Project	IEEE 802.16 Broadband Wireless Access Working Group < http://ieee802.org/16 >	
Title	Comment on MS context transfer	
Date Submitted	2008-05-09	
Source(s)	Hyunjeong Kang, Jungje Son, Youngbin Chang Samsung Electronics, Suwon, Korea	E-mail: hyunjeong.kang@samsung.com
	Rakesh Taori Samsung Advanced Institutes of Technology (SAIT)	
Re:	IEEE802.16-08/020"IEEE 802.16 Working Group Letter Ballot Recirc #28c: Announcement"	
Abstract	This contribution proposes a clarification on MS context transfer for HO optimization.	
Purpose	Discuss and adopt the proposed text in the TG16j draft.	
Notice	<i>This document does not represent the agreed views of the IEEE 802.16 Working Group or any of its subgroups. It represents only the views of the participants listed in the "Source(s)" field above. It is offered as a basis for discussion. It is not binding on the contributor(s), who reserve(s) the right to add, amend or withdraw material contained herein.</i>

Comment on MS context transfer

[Change subclause 6.3.22.2.11.3 as follows:]

Figure 157e—Serving station initiated transfer (Intra-MR)

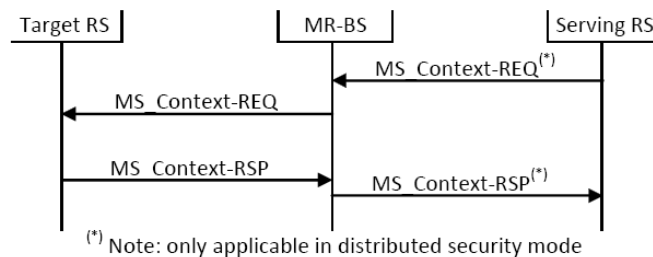
Figures 157e and 157f show examples of serving station initiated transfer in MS handover operation in Intra-MR and Inter-MR operating in distributed security mode, respectively. In the examples, the MS_Context-REQ message sent by the serving RS station contains SS MAC Address TLV, BSID TLV and TLVs related to MS context. The BSID TLV represents the target station. Therefore, when the MR-BS receives the MS_Context-REQ from the serving RS, it examines the BSID TLV. If the BSID TLV indicates the MR-BS itself, the MR-BS sends back MS_Context-RSP to the serving RS. If it indicates a subordinate RS of the MR-BS, the MR-BS sends MS_Context-REQ with type=0 to the subordinate RS after removing BSID TLV. Then the subordinate RS sends ~~back~~ MS_Context-RSP ([in response to receiving MS_Context-REQ](#)) and the MS_Context-RSP is sent to the serving RS through the MR-BS. If the BSID does not indicate a station within the MR cell, the MR-BS sends a message to the backbone network to inform the target station of MS context.

Figure 157g—Target station initiated transfer (Intra-MR)

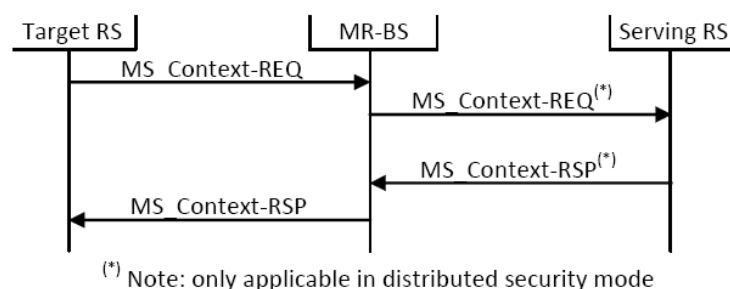
Figures 157g and 157h show examples of target station initiated transfer in MS handover operation in Intra-MR and Inter-MR operating in distributed security, respectively. In the examples, the MS_Context-REQ message sent by the target station contains SS MAC Address TLV, BSID TLV. The BSID TLV represents the serving station. Therefore, when the MR-BS receives the MS_Context-REQ from the target RS, it examines the BSID TLV. If the BSID TLV indicates the MR-BS itself, the MR-BS sends back MS_Context-RSP to the target RS. If it indicates a subordinate RS of the MR-BS, the MR-BS sends MS_Context-REQ with type=1 to the ~~subordinate~~ RS after removing the BSID TLV. Then the ~~subordinate~~ RS sends ~~back~~ MS_Context-RSP [in response to the MS_Context-REQ and the MS_Context-RSP is sent](#) to the target RS through the MR-BS. The MS_Context-RSP should contain TLVs related to MS context. If the BSID does not indicate a station within the MR cell, the MR-BS sends a message to the backbone network to inform the [serving target](#) station of [the request for](#) MS context. The message sent to the backbone is out of scope of this specification.
